Item ID: D407-667-105TRN Accept ***N900040100*** Setup Start ***NS1***
 Revision ID: Stop ***NS2***
 Item Name: Crosstube Turning Detail
 Start Date: 1/30/15 Start Qty: 1.00 ***1*** Cust Item ID:
 Required Date: 2/20/15 Req'd Qty: 1.00 ***1*** Customer:
 Reference:

DART AEROSPACE LTD	Work Order:	129267
Description: Crosstube Assembly	Part Number:	D407-667-145
Inspection Dwg: D407-667-145 Rev: C		Page 1 of 1

DRAWING NO. D407-667-145	TITLE CROSSTUBE ASS'Y (407 HIGH FWD)	REV. C	DART AEROSPACE LTD ENGINEERING ORDER		D.E.O. NO. D407-667-145-C-1	SHEET NO. SHEET 1 OF 1	SCALE NTS
DRAWN 90	CHECKED ASS	MFG. APPR. 18	APPROVED WD		DE APPR. H		
DATE 11.07.15	DATE 11.07.22	DATE 11.07.22	DATE 11/07/22		DATE 11.07.21

DRAWING NO. D407-667-145	TITLE CROSSTUBE ASS'Y (407 HIGH FWD)	REV. C	DART AEROSPACE LTD ENGINEERING ORDER	D.E.O. NO. D407-667-145-C-2	SHEET NO. SHEET 1 OF 1	SCALE NTS
DRAWN AJS	CHECKED	MFG. APPR. <i>E</i>	APPROVED <i>AP</i>	DE APPR. <i>[Signature]</i>		
DATE 12.08.02	DATE 12.08.02	DATE 12.08.02	DATE 12.08.02	DATE 12.08.02	DATE 12.08.02

DETAIL P
 BONDING STRAP INSTALLATION 2 PL

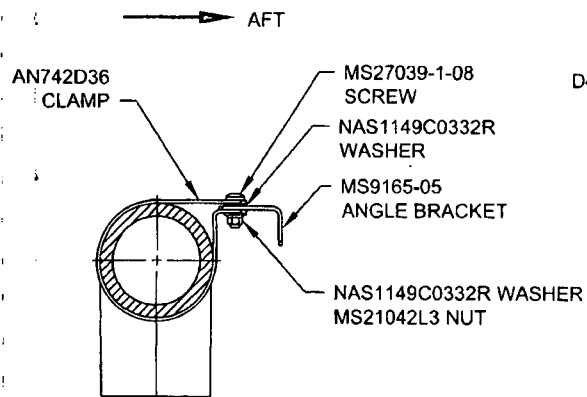
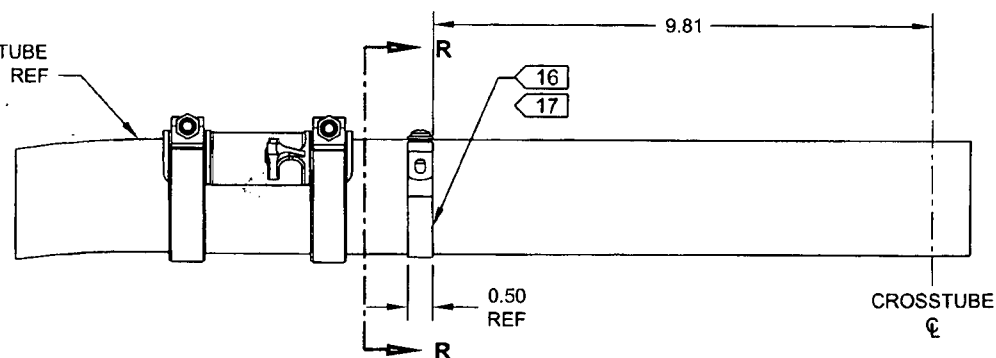
ADD ELECTRICAL GROUNDING STRAP

ITEM	QTY -145	PART NUMBER	DESCRIPTION	
1	X	D407-667-145	CROSSTUBE ASSEMBLY (407 HIGH FWD)	
10	2	AN742D36	CLAMP	} ADD
11	2	MS9165-05	ANGLE BRACKET	
12	2	MS21042L3	NUT (OR MS21042-3)	
13	2	MS27039-1-08	SCREW	
14	4	NAS1149C0332R	WASHER (OR AN960C10L)

- 16) MASK AREA UNDER CLAMP PRIOR TO PAINTING
 - 17) SEAL EDGES WHERE AN742D36 CLAMP MEETS WITH THE CROSSTUBE USING SIKAFLEX-241/-291 OR MIL-S-8802 CLASS B2 OR PROSEAL 890 SEALANT
 - 18) PERFORM RESISTANCE CHECK TO ENSURE MAX RESISTANCE IS 10 MILLIOHMS
- } ADD
